2020 TOWER REDEVELOPMENT

SITE PLAN

LANDSCAPE PLAN

SHEET 7 OF 12

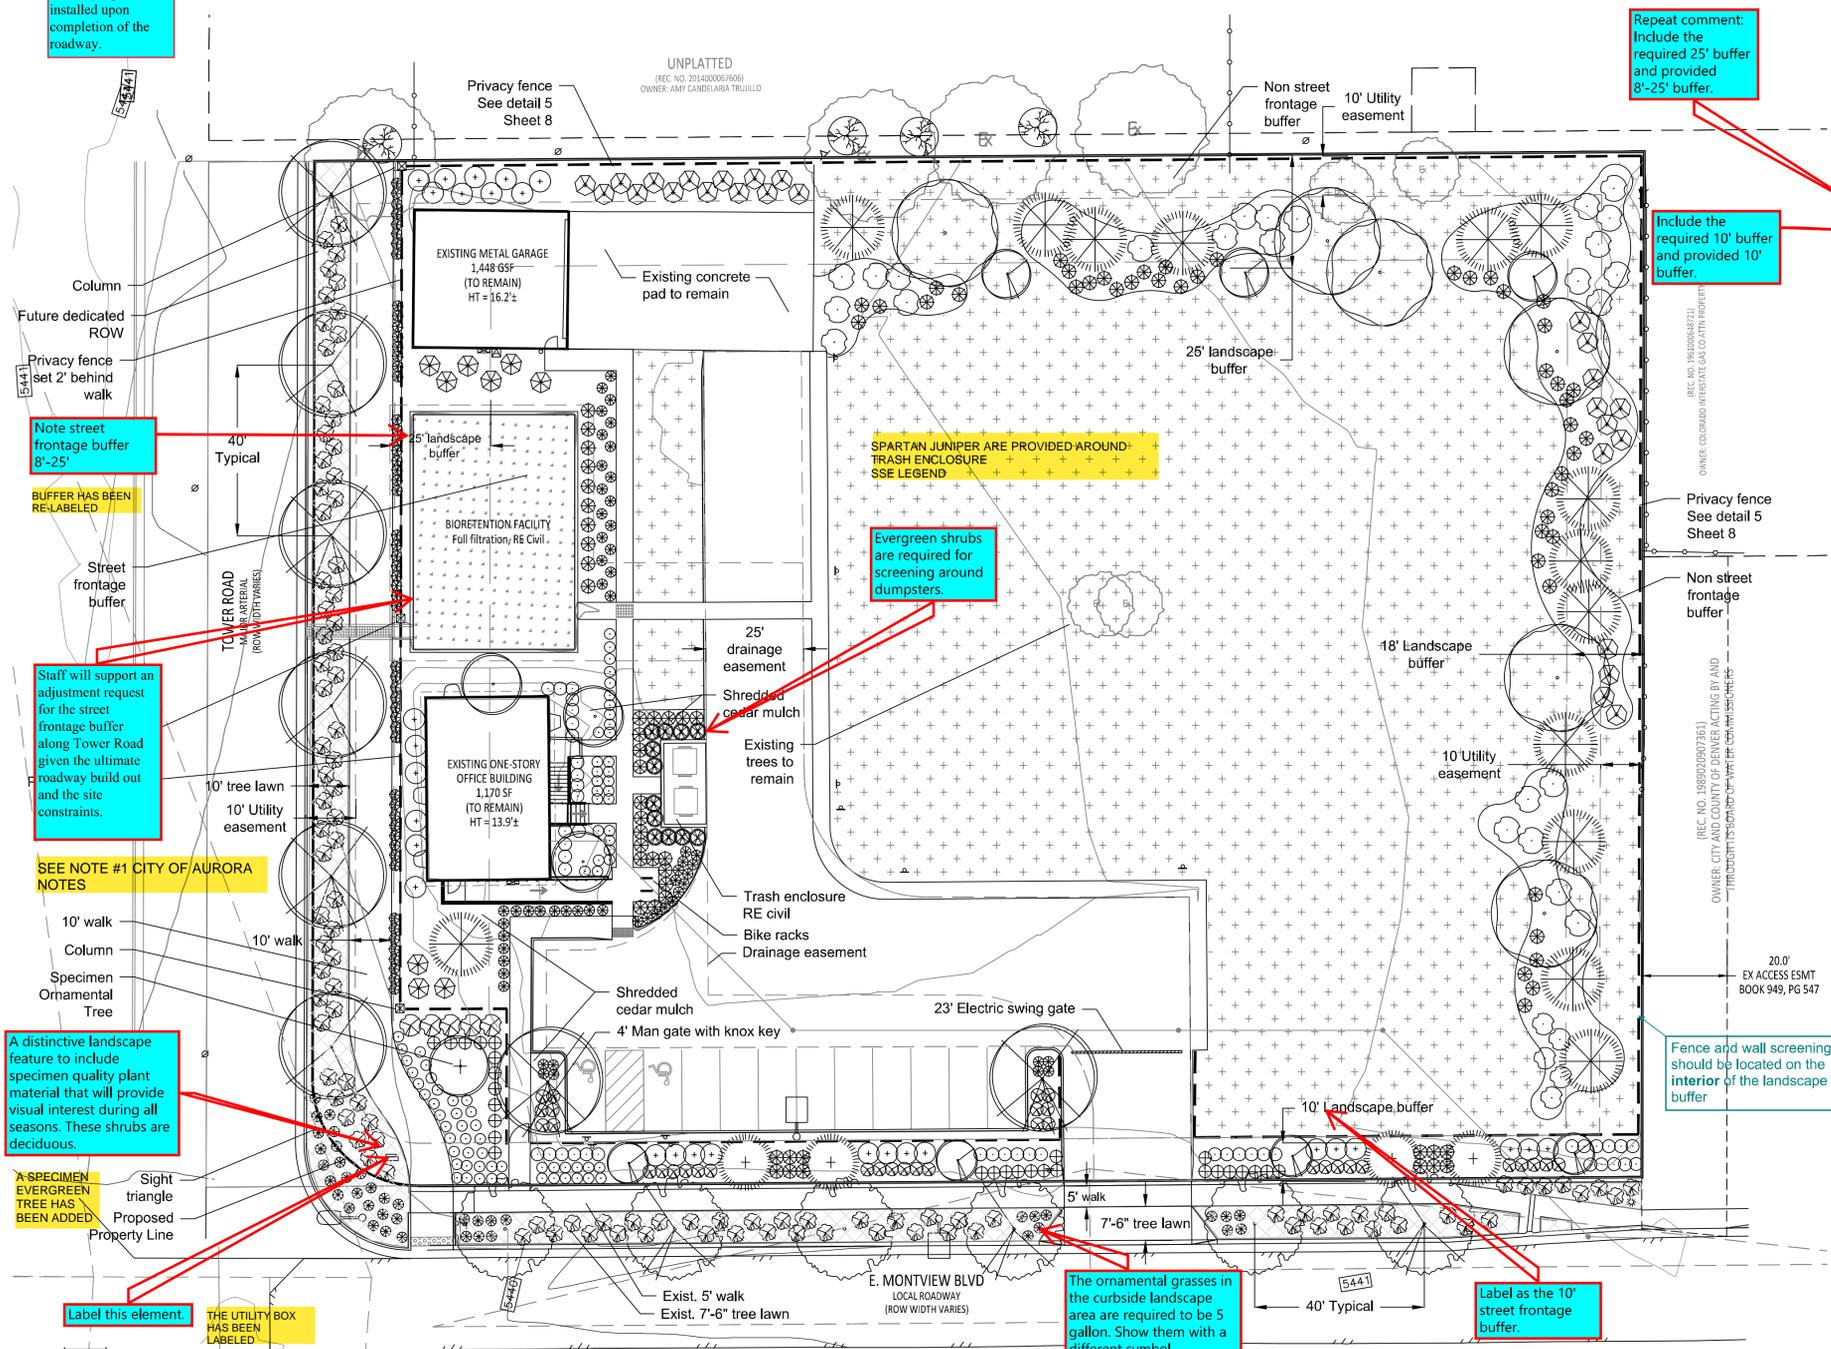
Please add the note:
A deferral has been requested, if approved, the landscaping will be installed upon completion of the roadway.

Repeat comment:
Include the required 25' buffer and provided 8'-25' buffer.

Provide an asterisk and a note at the bottom of the table that an adjustment has been requested.

Note # of required/provided evergreen trees and percentages.

Change to 10'-25'

Change to 8'-25'

Repeat comment:
Update this note to address the deferral being requested for landscaping along Tower Road.

Include the tree Legend and symbols on this sheet.

Note street frontage buffer 8'-25'

Staff will support an adjustment request for the street frontage buffer along Tower Road given the ultimate roadway build out and the site constraints.

A distinctive landscape feature to include specimen quality plant material that will provide visual interest during all seasons. These shrubs are deciduous.

Label this element

Provide % of the overall landscape area.

Evergreen shrubs are required for screening around dumpsters.

The ornamental grasses in the curbside landscape area are required to be 5 gallon. Show them with a different symbol.

Fence and wall screening should be located on the interior of the landscape buffer

Repeat comment:
Include the required 25' buffer and provided 8'-25' buffer.

Include the required 10' buffer and provided 10' buffer.

SEE NOTE #1 CITY OF AURORA NOTES

BUFFER WIDTHS PROVIDED & REQUIRED HAVE BEEN ADDED

BUFFER WIDTHS REVISED

SEE NOTE #1 ABOVE, IT ADDRESSES THE DEFERRAL BEING REQUESTED

DEFERRAL IS ADDRESSED IN NOTE #5

PLANT SYMBOLS HAVE BEEN ADDED TO LEGEND

BUFFER HAS BEEN RELABELLED

SEE NOTE #1 CITY OF AURORA NOTES

A SPECIMEN EVERGREEN TREE HAS BEEN ADDED

THE UTILITY BOX HAS BEEN LABELED

sf areas have been added and percentages

SPARTAN JUNIPER ARE PROVIDED AROUND TRASH ENCLOSURE SEE LEGEND

CURBSIDE GRASSES HAVE BEEN CHANGED TO 5 GALLON. SYMBOL HAS BEEN CHANGED

Label changed

BUFFER WIDTHS PROVIDED & REQUIRED HAVE BEEN ADDED
